Title - Sujet STATION QUALITÉ DE L'AIR		
Solicitation No. - N° de l'invitation EF970-151211/A		Amendment No. - N° modif. 003
Client Reference No. - N° de référence du client EF970-151211		Date 2015-02-18
GETS Reference No. - N° de référence de SEAG PW-\$QCW-024-16286		
File No. - N° de dossier QCW-4-37258 (024)		CCC No./N° CCC - FMS No./N° VME
Solicitation Closes - L'invitation prend fin at - à 02:00 PM on - le 2015-02-25		Time Zone Fuseau horaire Heure Normale du l'Est HNE
F.O.B. - F.A.B. Plant-Usine: <input type="checkbox"/> Destination: <input type="checkbox"/> Other-Autre: <input type="checkbox"/>		
Address Enquiries to: - Adresser toutes questions à: Jean, Serge		Buyer Id - Id de l'acheteur qcw024
Telephone No. - N° de téléphone (418) 649-2882 ()		FAX No. - N° de FAX (418) 648-2209
Destination - of Goods, Services, and Construction: Destination - des biens, services et construction:

AMENDMENT 003 AIR QUALITY STATION PROJECT

The objective of amendment 003 is to modify the statement of work, to provide answers to questions 15 to 24 and to postpone the invitation to tender date:

Figure 1:

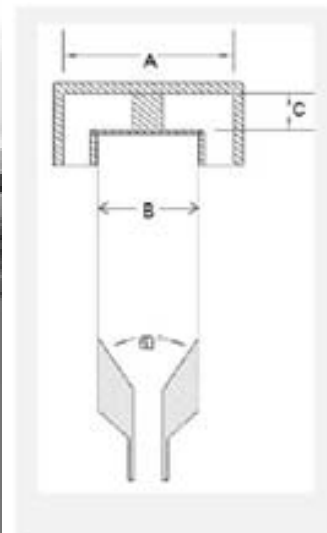
The following table summarizes the performance expected of gaseous pollutant measurement instruments. All the devices shall also be designed for federal reference methods or the federal equivalent methods of the United States Environmental Protection Agency ("referenceequivalent-methods-list.pdf" included in Appendix 4) except for PM_{TOT} measurements. These measurements will need to be performed using an instrument similar to the one used for PM_{2.5} measurements. However, in order to make possible any eventual comparisons between PM_{TOT} measurements of the fixed station and those of the mobile station operated by Environment Canada, the air inlet head of the PM_{TOT} analyzer should be of "mushroom" type (please refer to the images below for examples).
